**From:** "Head, Sara" <Sara.Head@aecom.com>  
**To:** "Felicia Miller" <Fmiller@energy.state.ca.us>  
**CC:** "Tony Penna" <tonypenna@inlandenergy.com>, <MICHAEL.CARROLL@LW.com>, "Ca..."  
**Date:** 5/19/2009 6:51 PM  
**Subject:** FW: Palmdale Hybrid - Land Use  
**Attachments:** Figure\_5-7-5\_Farmland\_Before.pdf; Figure\_5-7-5R\_Farmland\_After.pdf

<b>DOCKET</b>	
<b>08-AFC-9</b>	
<b>DATE</b>	May 19 2009
<b>RECD.</b>	MAY 20 2009

**Palmdale Hybrid Power Project**

**Figure 5.7-5**  
**Important Farmland in the Vicinity of the Project and Linear Facilities**

**Mapsheets 01 of 14**

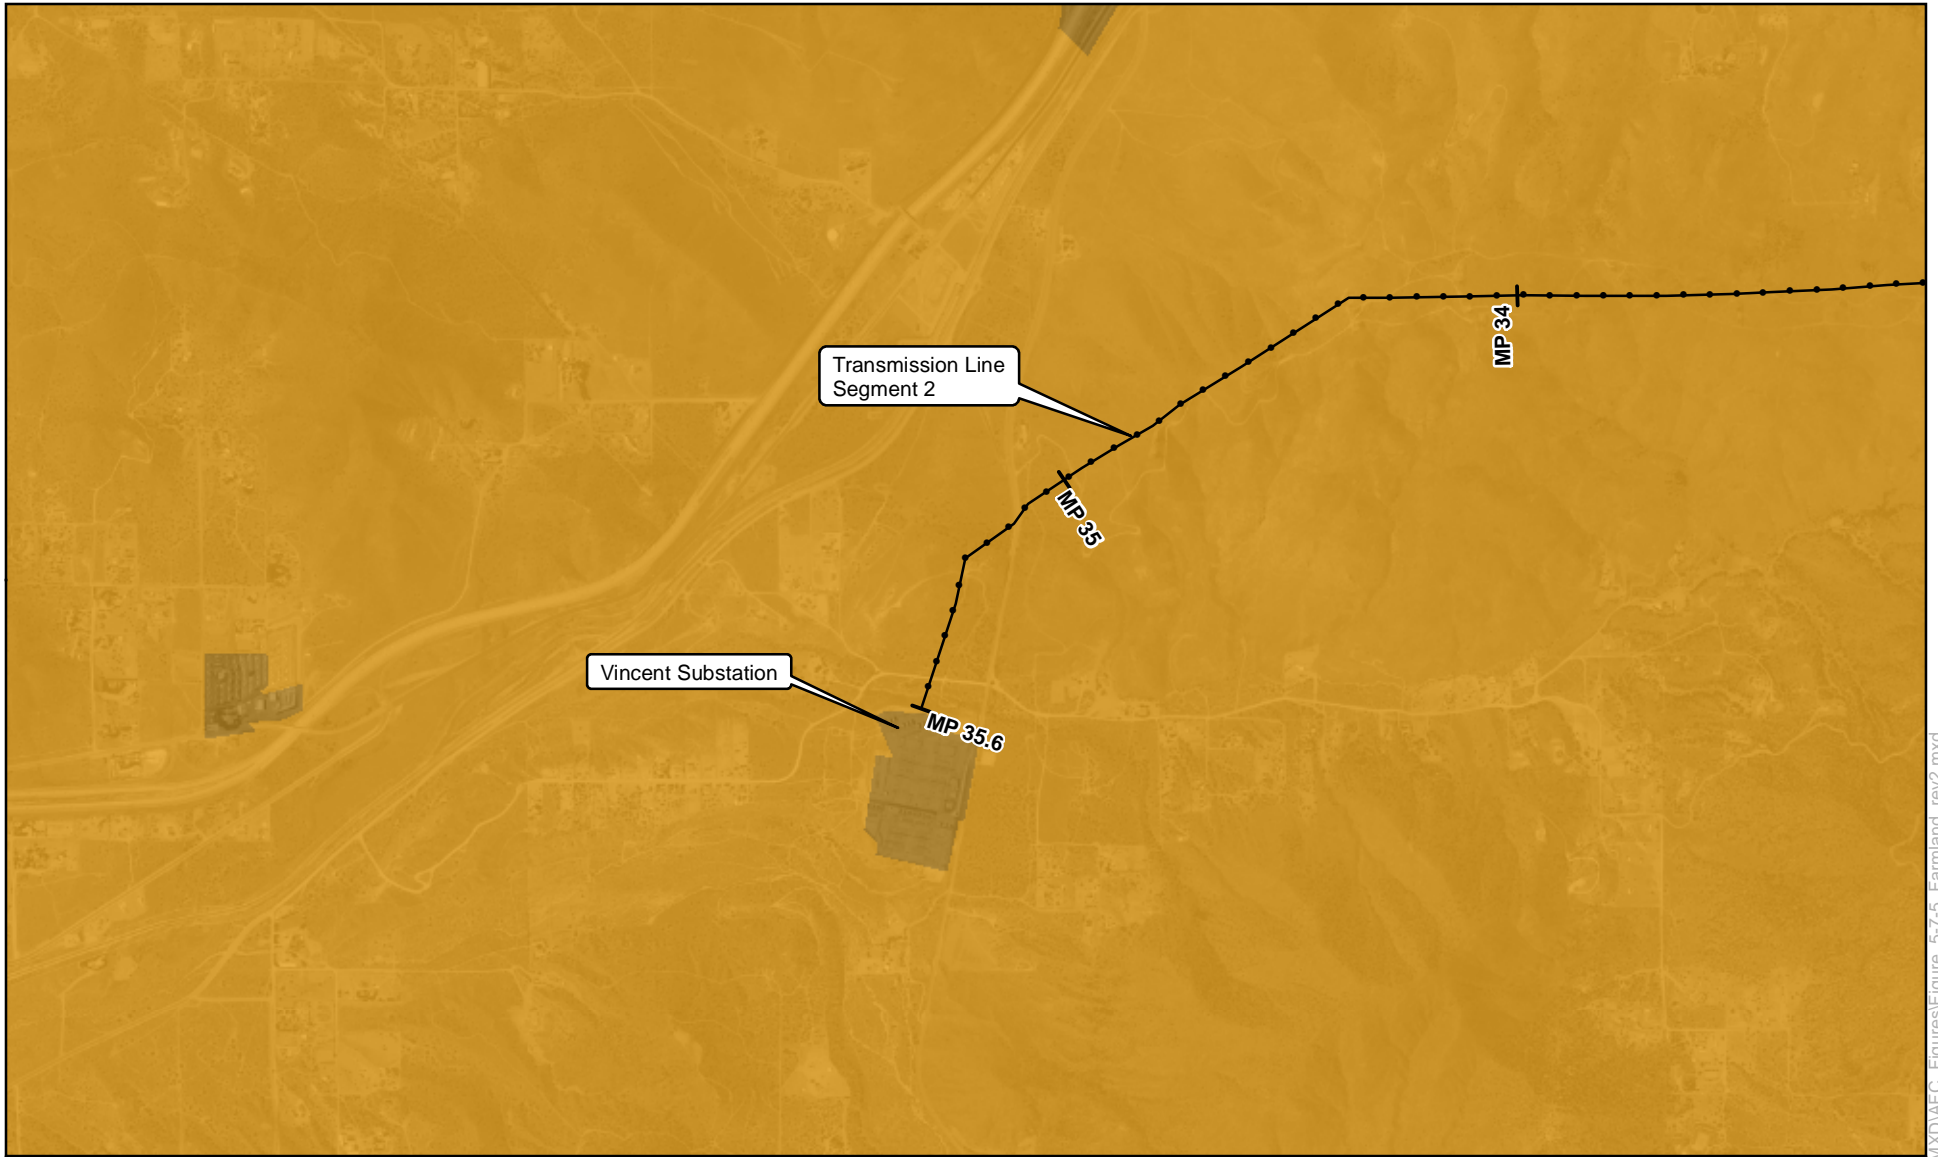
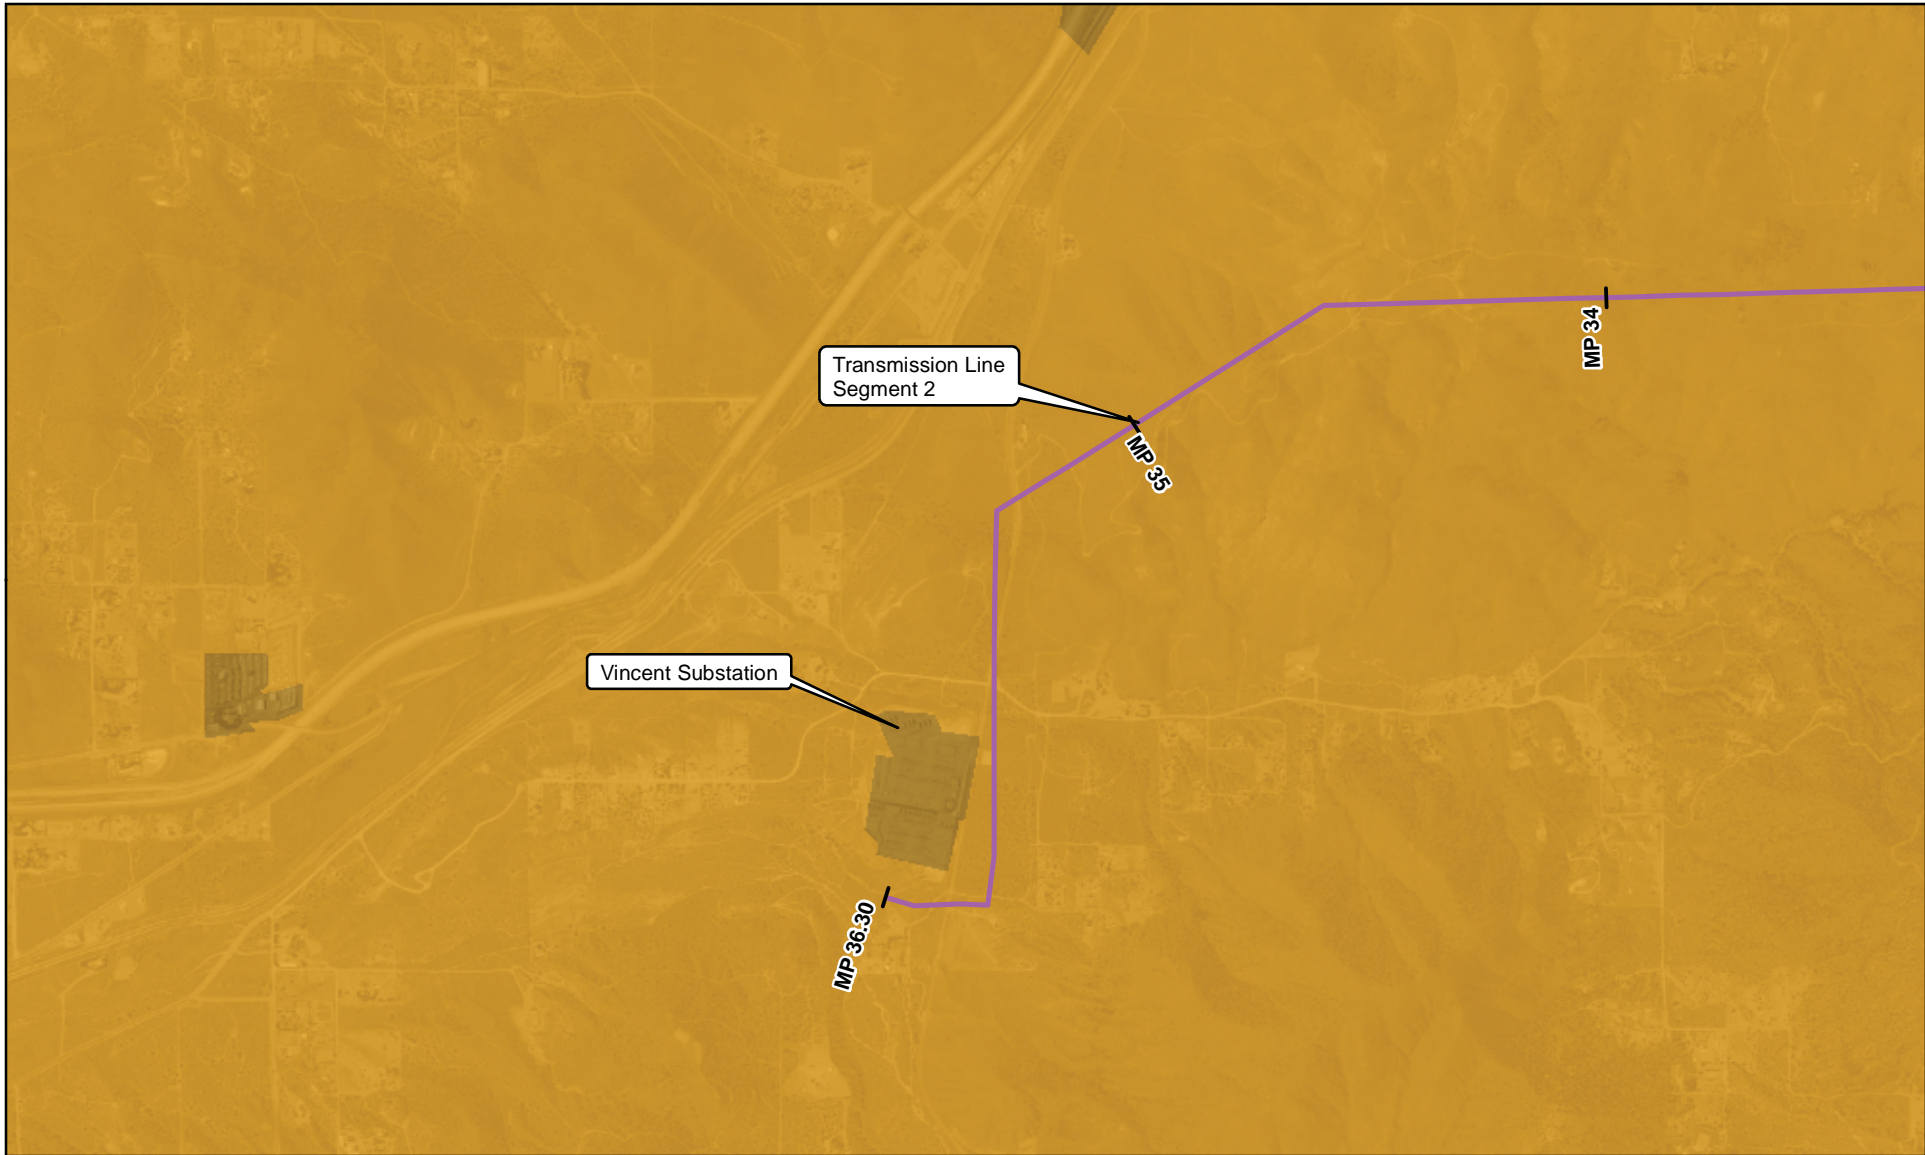
- Although the revised map figures (specifically, 5.7-2a and 2c, 5.7-3a and 3c, and 5.7-5) that have been provided in response to Data Request No. 142 illustrate the location of the linear facilities with respect to General Plan Land Use Designations, Zoning and Important Farmlands, the scale (e.g., 1 inch = 2.5 miles) of these figures makes it difficult to discern affected designated lands, and the revised routes. For the portions of the linear facilities where the routes have been revised, please provide the figures at an easily legible scale (e.g., 1 inch = ½ mile).

Mapsheet 01 shows the changes to the potable water pipeline, natural gas pipeline, and the sanitary wastewater line. The potable water pipeline follows the onsite access road down from the site entrance and into the power block from the west -- instead of continuing further east along E Ave M and then turning south on 15th St E (eastern border of the PHPP plant site and Plant 42 boundary) into the power block from the east. The natural gas pipeline also follows the onsite access road into the new gas metering station on the western boundary -- instead of going to the power block from the east. The sanitary wastewater line now goes up 15th St E but turns east at E Ave M to interconnect with a sanitary sewer main about a mile to the east of the plant site -- instead of continuing up 15th St E about a mile to the north.
